GENWAL RESOURCES, INC
CRANDALL CANYON MINES
C/015/032

CHANGE TO THE
MINING AND RECLAMATION PLAN
TO INCLUDE

MINE DISCHARGE WATER
IRON TREATMENT FACILITY

**NOTE: THIS SUBMITTAL IS A RESPONSE TO
DEFICIENCIES TO THE ORIGINAL SUBMITTAL
OF OCTOBER 13, 2009**

**FIGURE 13B
 INSTALLATION OF RE-ROUTED CULVERT UD-3
 SIDE VIEW**

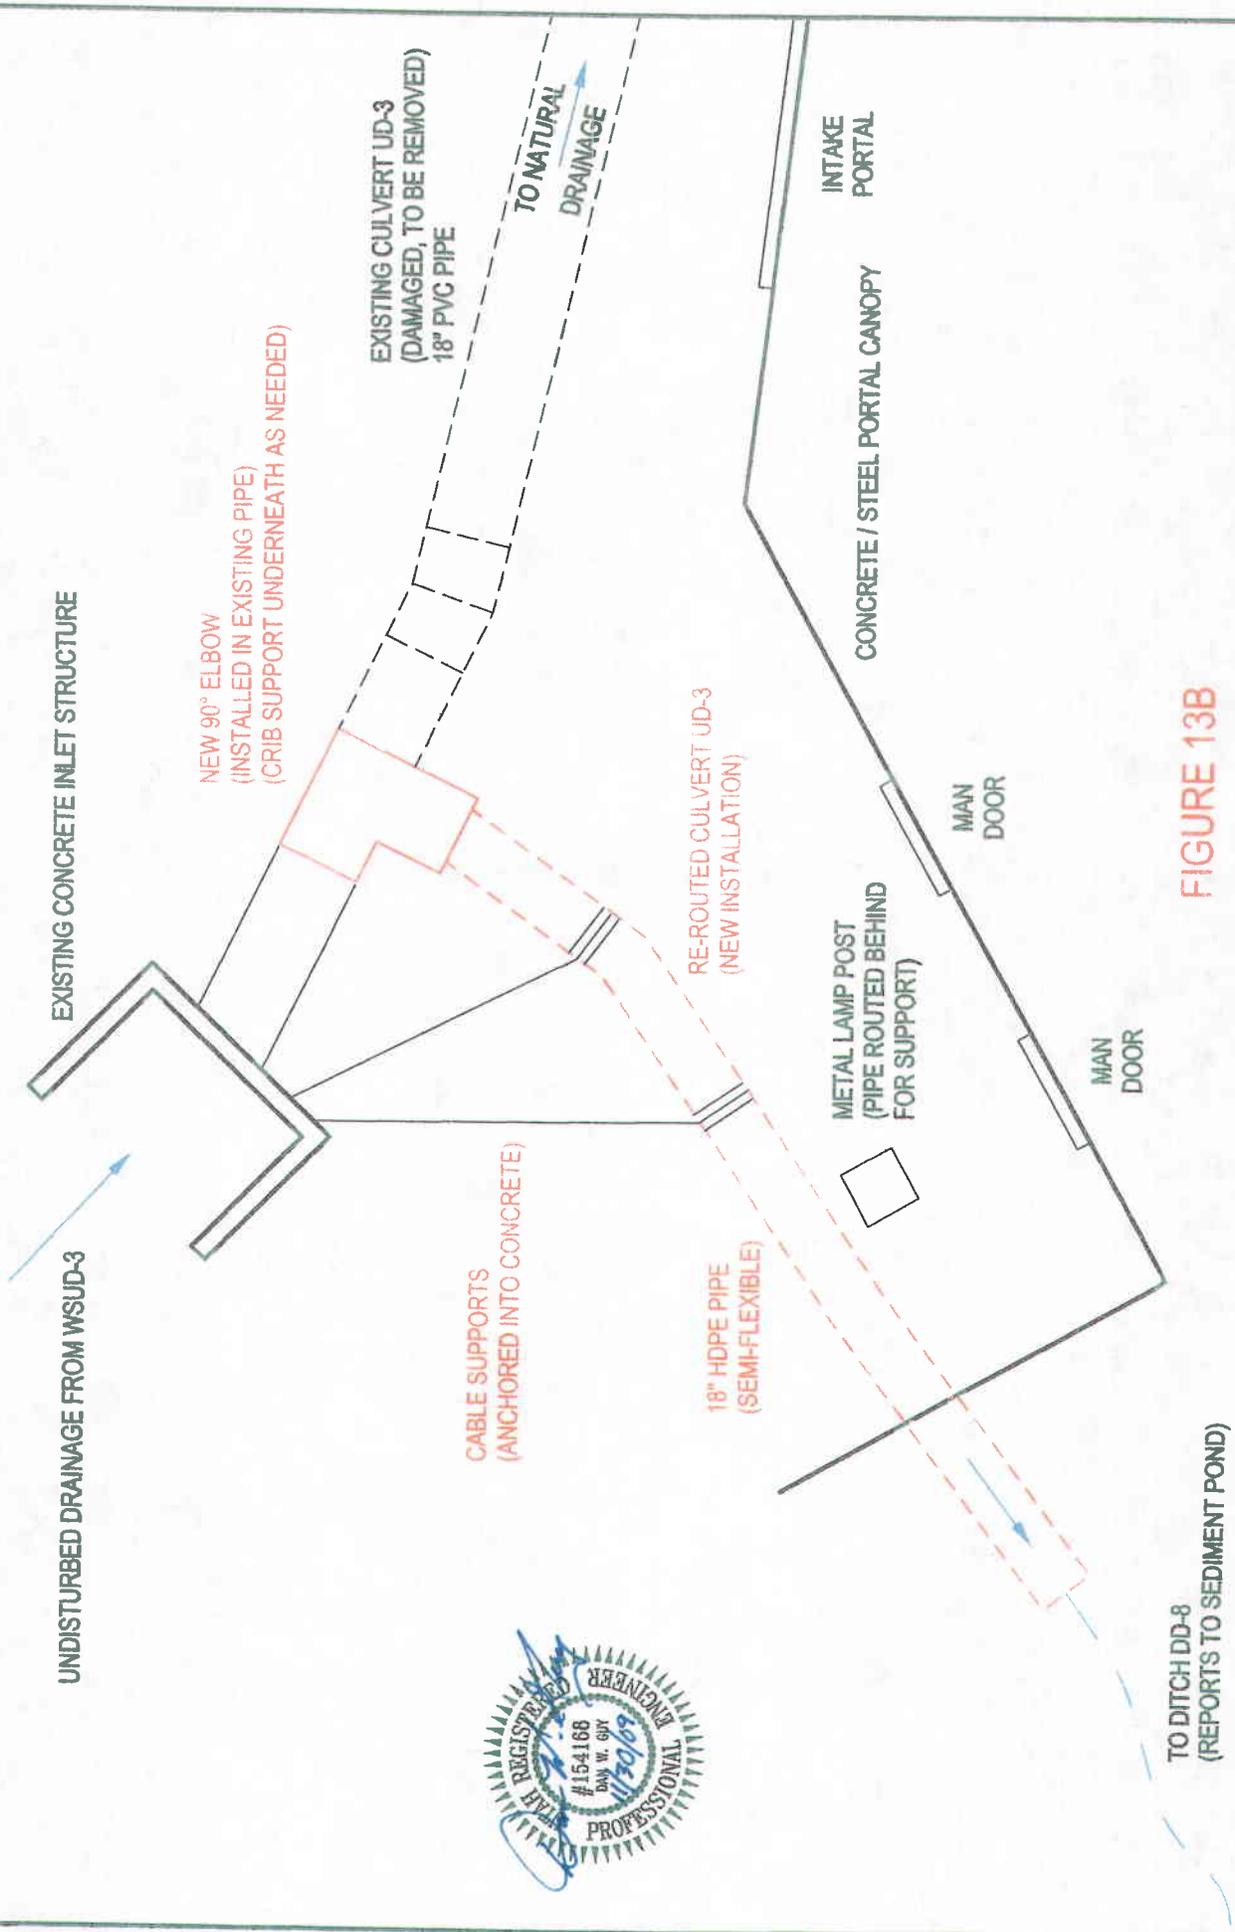
- (e) When the Crandall Canyon Mine Portals were sealed as a result of the 2007 disaster, culvert system UD-3 which diverts undisturbed drainage area WSUD-3, was damaged beyond repair. Therefore it was decided to re-route UD-3 as shown on Figures 13A and 13B. Culvert UD-3 now reports to Disturbed Ditch DD-8, Culvert C-1, Disturbed Ditch DD-5, Culvert C-12 and ultimately into the Sediment Pond. Calculations show that all affected ditches, culverts and the Sediment Pond are adequately sized to handle the increased flow from WSUD-3 (See Tables 3, 5, 6, 7 and 11).*

- (e) When the Crandall Canyon Mine Portals were sealed as a result of the 2007 disaster, culvert system UD-3 which diverts undisturbed drainage area WSUD-3, was damaged beyond repair. Therefore it was decided to re-route UD-3 as shown on Figures 13A and 13B. Culvert UD-3 now reports to Disturbed Ditch DD-8, Culvert C-1, Disturbed Ditch DD-5, Culvert C-12 and ultimately into the Sediment Pond. Calculations show that all affected ditches, culverts and the Sediment Pond are adequately sized to handle the increased flow from WSUD-3 (See Tables 3, 5, 6, 7 and 11).*
